Application Number: DA2023/0934
Address: Lot 63 DP 8075 , 55 Bower Street, MANLY NSW 2095
Proposed Development: Demolition works and construction of a dwelling house including swimming pool

NOTICE OF DETERMINATION OF A DEVELOPMENT APPLICATION

Application Number:	DA2023/0934 PAN-350342
Applicant:	Chris Meyer 1/80 Albion Street SURRY HILLS NSW 2010
Property:	Lot 63 DP 8075 55 Bower Street MANLY NSW 2095
Description of Development:	Demolition works and construction of a dwelling house including swimming pool
Determination:	Approved Consent Authority: Northern Beaches Council
Date of Determination:	08/04/2024
Date from which the consent operates:	08/04/2024
Date on which the consent lapses:	08/04/2029

17. Stormwater Treatment Measures - Minor

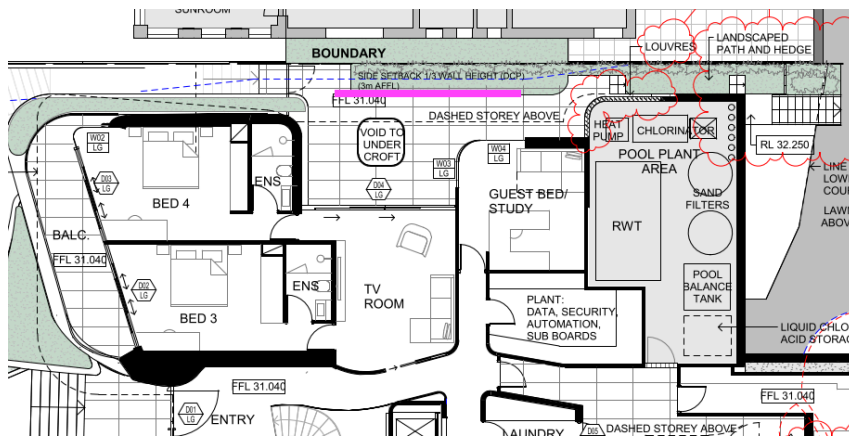
The applicant must install a filtration device (such as a sediment control pit or absorption trench) that captures organic matter and coarse sediments prior to discharge of stormwater from the land. All stormwater treatment measures must make provision for convenient and safe regular inspection, periodic cleaning, and maintenance.

Details demonstrating compliance are to be submitted to the Certifier for approval prior to the issue of the Construction Certificate.

18. Amendments to the approved plans

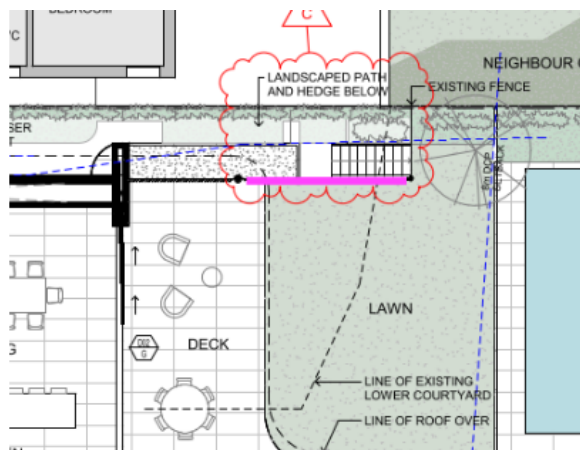
a) **"Lower Ground Level" Terrace Privacy Screen** - A privacy screen with a minimum height of 1.7 metres (measured from finished floor level) is to be erected for the eastern extent of the "Lower Ground Level" terrace demonstrated by the pink line on the figure below. This privacy screen shall be 900mm from the eastern boundary and extend for a length of 6 metres. The privacy screen shall be of fixed panels or louver style construction (with a maximum spacing of 30mm), in materials that complement the design of the approved development.

b) **"Upper Ground Level" Lawn Privacy Screen** - A privacy screen with a minimum height of 1.7 metres (measured from finished deck/lawn level) is to be erected for the eastern extent of the "Upper Ground Level" lawn demonstrated by the pink line on the figure below. This privacy screen shall be 2 metres from the eastern boundary and extend for a length of 4.5 metres.

Details demonstrating compliance are to be submitted to the Certifier prior to the issue of the Construction Certificate.
